04	07.02.19	Lights added/deleted/moved as per client comments, see revision clouds; LED strip incorporated on handrails, see revision clouds; bottom grilles have moved down, see revision clouds; MJ amended as per Client and Structural Engineer comments. Notes added on MJ in order to clarify real position; Brick Joints/Wall Lamps/RWP plates have been incorporated on Balconies; Key and Notes have been updated, see revision clouds.	AO
03	12.12.18	Movement joints added as per Walsh drawings; Sliding doors into balconies revised as per client change; General updates in line with updates on external openings.	AO
02	16.02.18	General updates as per revision clouds, material key added to the elevations.	GF
01	13.10.17	Stage 04 Main Building Submission	GF
-	17.05.17	Stage 03 Main Building Pack	GF
REV	DATE	NOTES	INT

JOB TITLE
 Stanley Sidings, 101 Camley Street, Camden

DRAWING TITLE / LOCATION
 North Block Envelope - Lower Levels

DRAWN BY	CHECKED	SCALE	STATUS
GFV	DMV	1:100@A1 / 1:200@A3	STAGE 05
PROJECT	DRAWING NO	REVISION	
16022	N AL 0020 006	04

DRAWN BY	CHECKED	SCALE	STATUS
DMV	GFV	1:100@A1 / 1:200@A3	STAGE 05
PROJECT	DRAWING NO	REVISION	
16022	N AL 0020 005	04

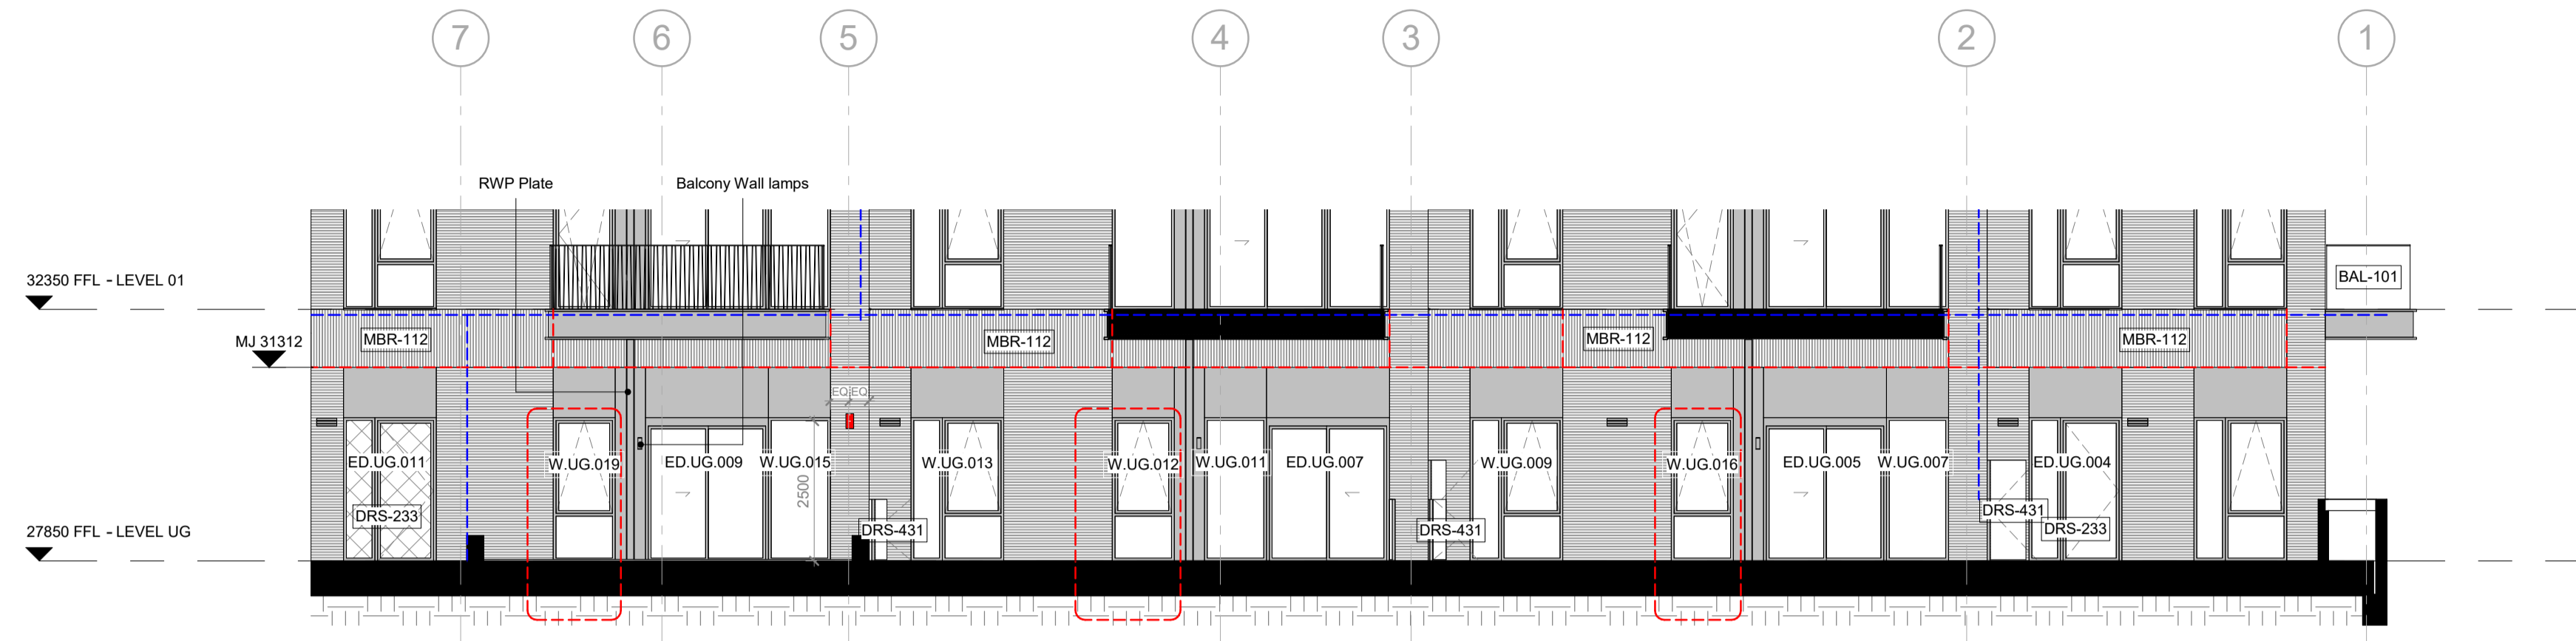
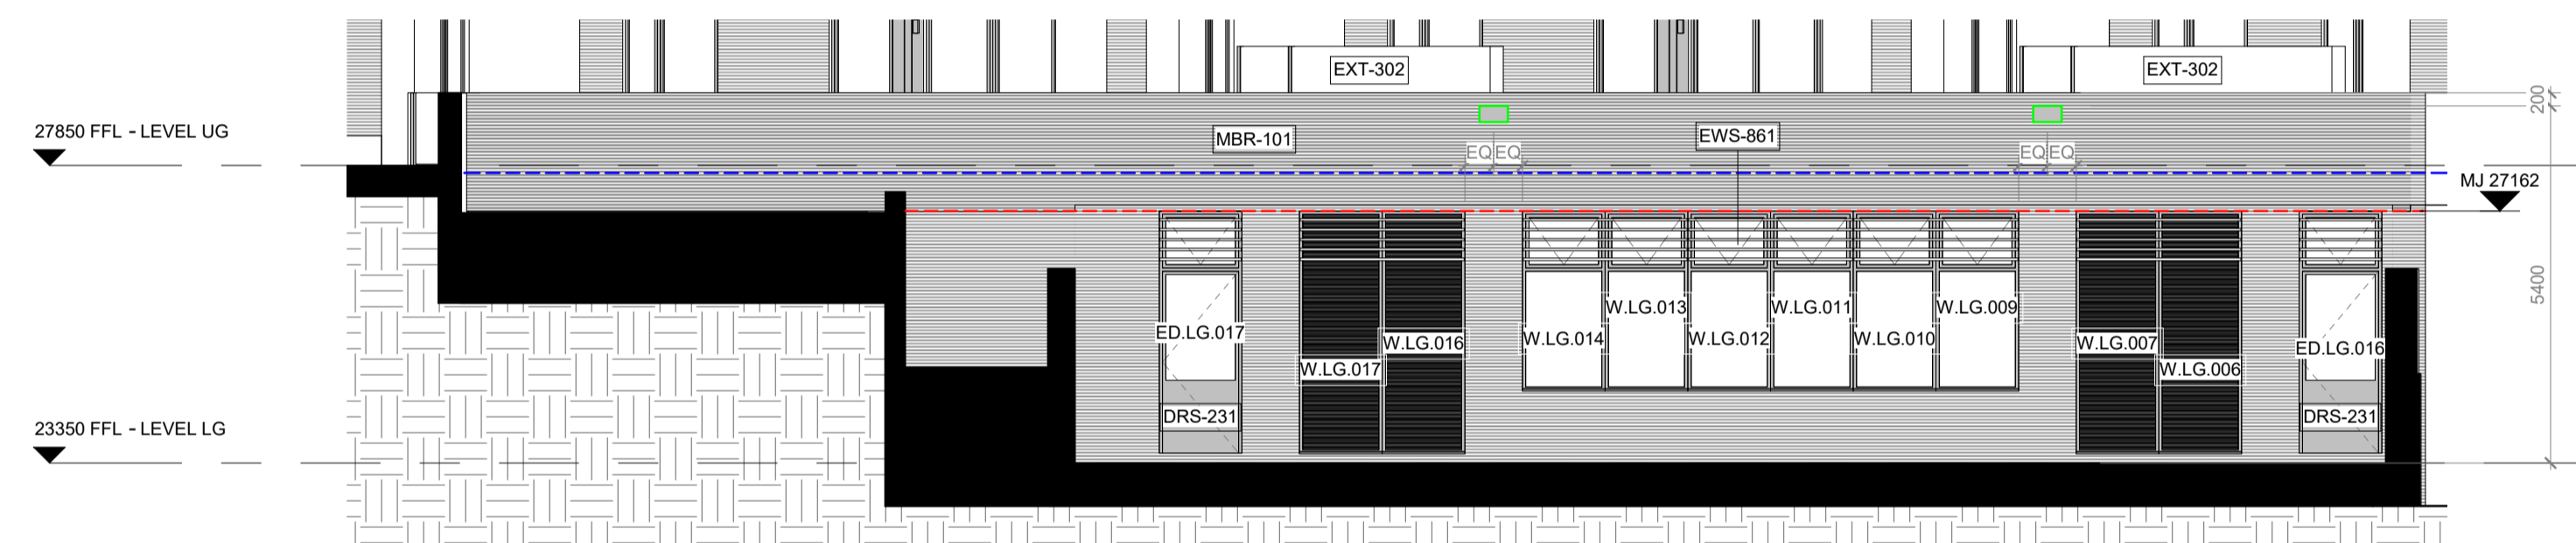
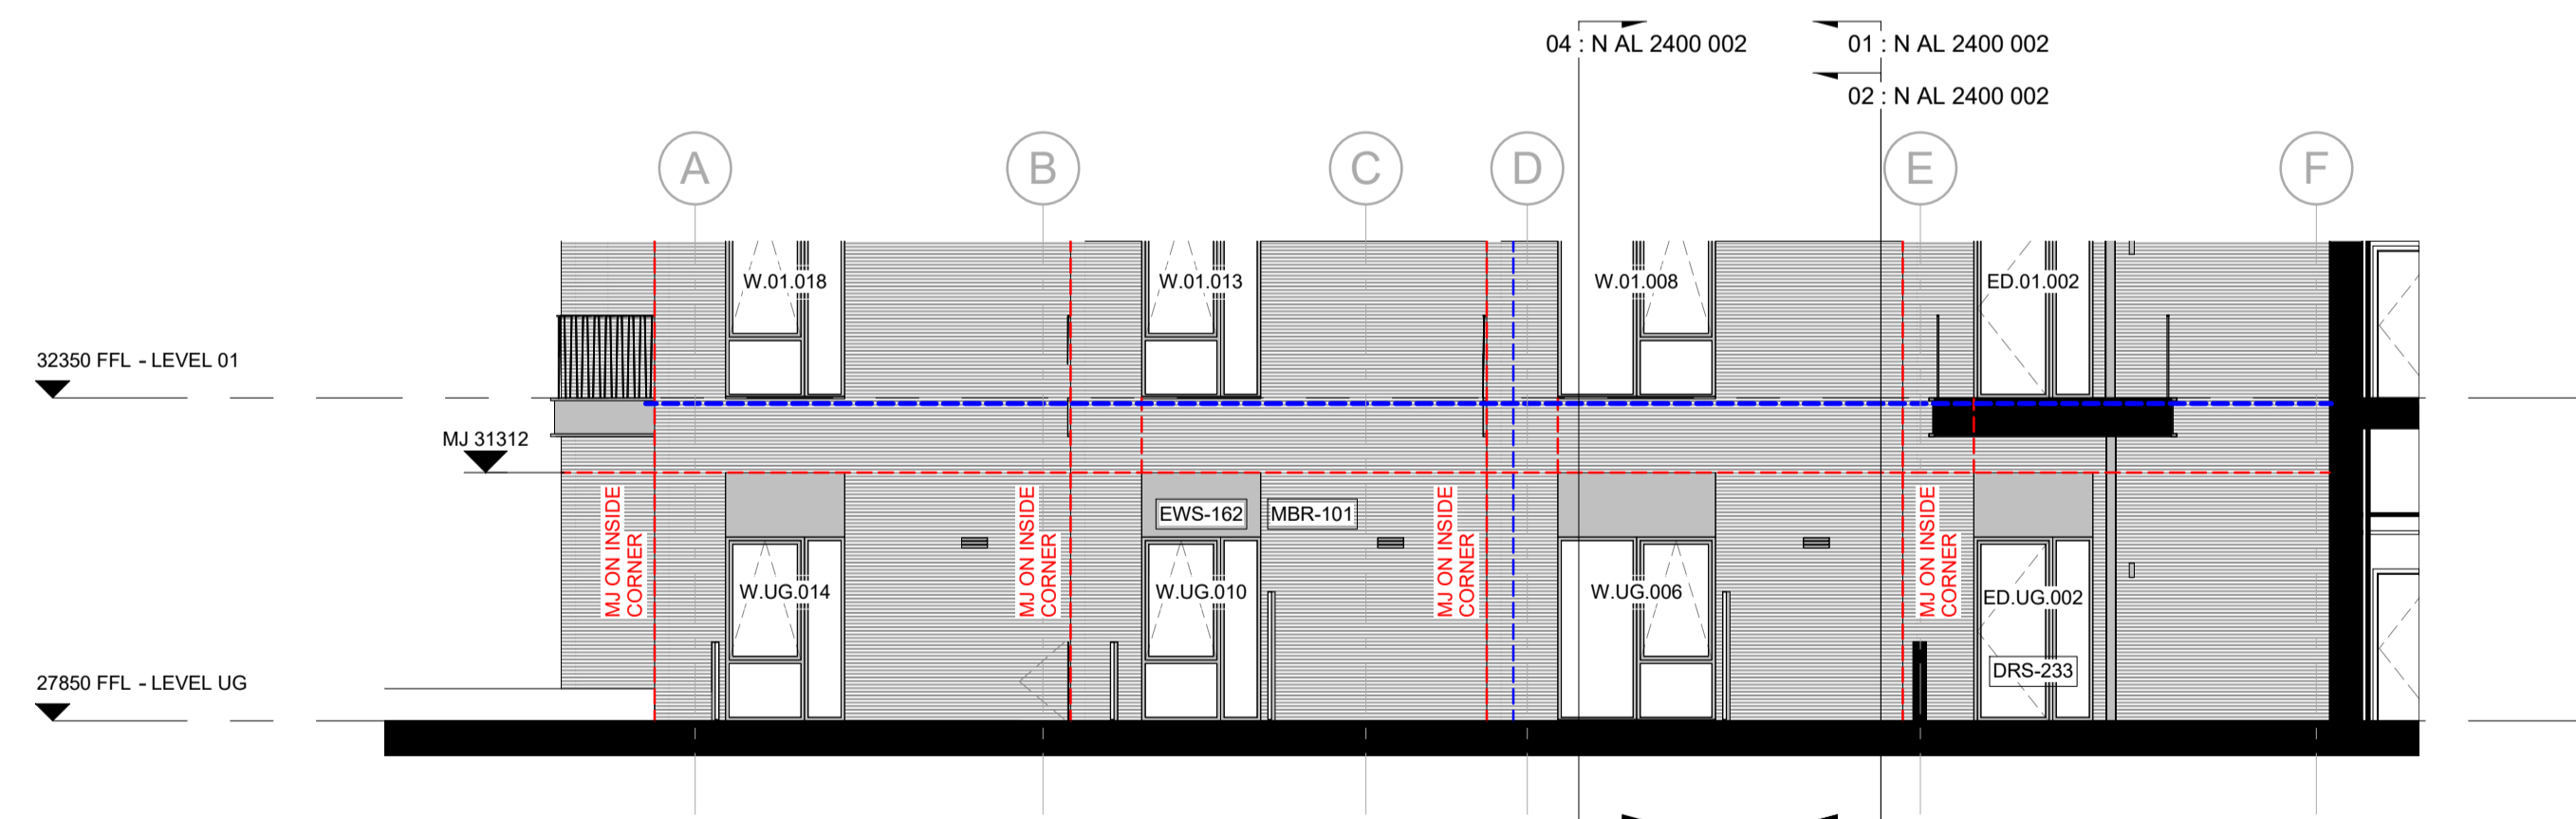
04	07.02.19	Lights added/deleted/moved as per client comments, see revision clouds; LED strip incorporated on handrails, see revision clouds; bottom grilles have moved down, see revision clouds; MJ amended as per Client and Structural Engineer comments. Notes added on MJ in order to clarify real position; Brick Joints/Wall Lamps/RWP plates have been incorporated on Balconies; Key and Notes have been updated, see revision clouds; 3x201A have been replaced on UG, see Rev Clouds.	AO
03	12.12.18	Movement joints added as per Walsh drawings; Sliding doors into balconies revised as per client change; General updates in line with updates on external openings.	AO
02	16.02.18	General updates as per revision clouds, material key added to the elevations.	GF
01	13.10.17	Stage 04 Main Building Submission	GF
-	17.05.17	Stage 03 Main Building Pack	GF
REV	DATE	NOTES	INT

DRAWN BY	CHECKED	SCALE	STATUS
MT	DV	1:100@A1 / 1:200@A3	STAGE 05
PROJECT	DRAWING NO	REVISION	
16022	N AL 0020 002	04

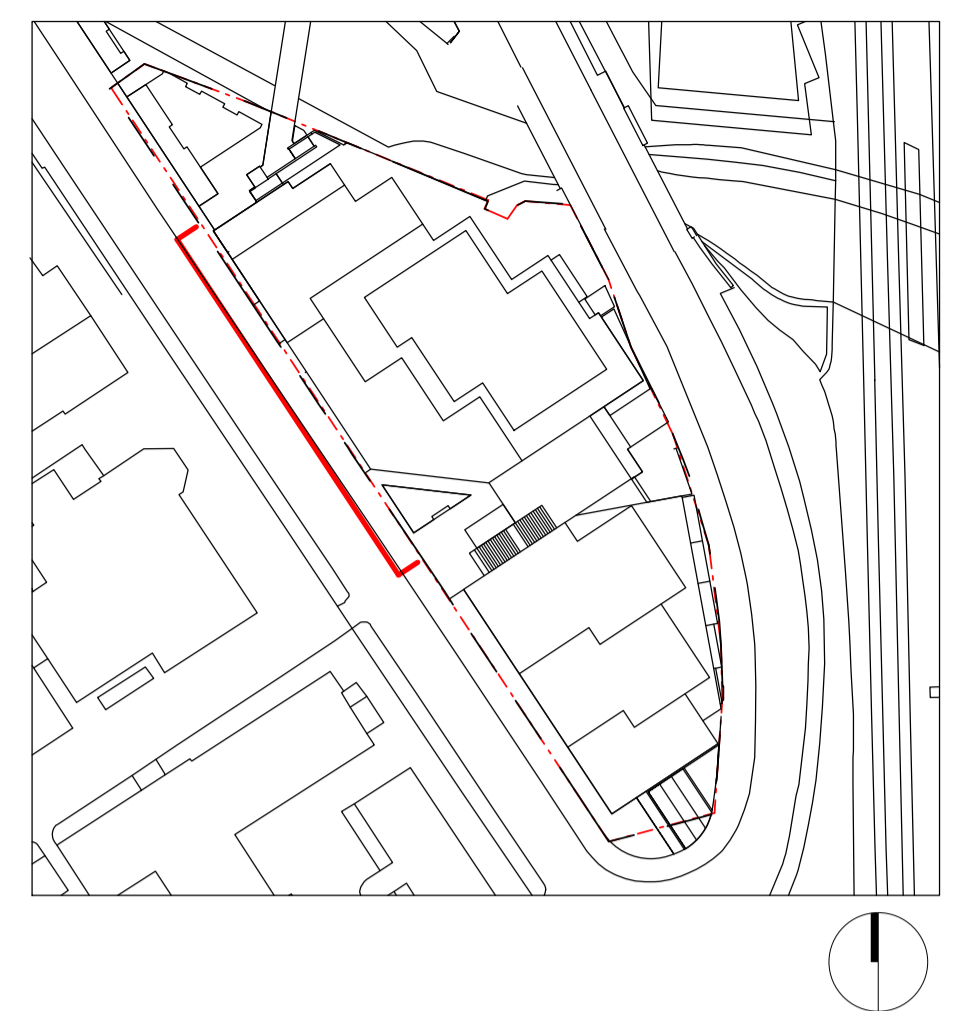
REV	DATE	NOTES	INT
04	07.02.19	Lights added/deleted/moved as per client comments, see revision clouds; LED strip incorporated on handrails, see revision clouds; bottom grilles have moved down, see revision clouds; MJ amended as per Client and Structural Engineer comments. Notes added on MJ in order to clarify real position; Brick Joints/Wall Lamps/RWP plates have been incorporated on Balconies; Key and Notes have been updated, see revision clouds.	AO
03	12.12.18	Movement joints added as per Walsh drawings. Sliding doors into balconies revised as per client change. General updates in line with updates on external openings.	AO
02	16.02.18	General updates as per revision clouds, material key added to the elevations.	GF
01	13.10.17	Stage 04 Main Building Submission	GF
-	17.05.17	Stage 03 Main Building Pack	GF
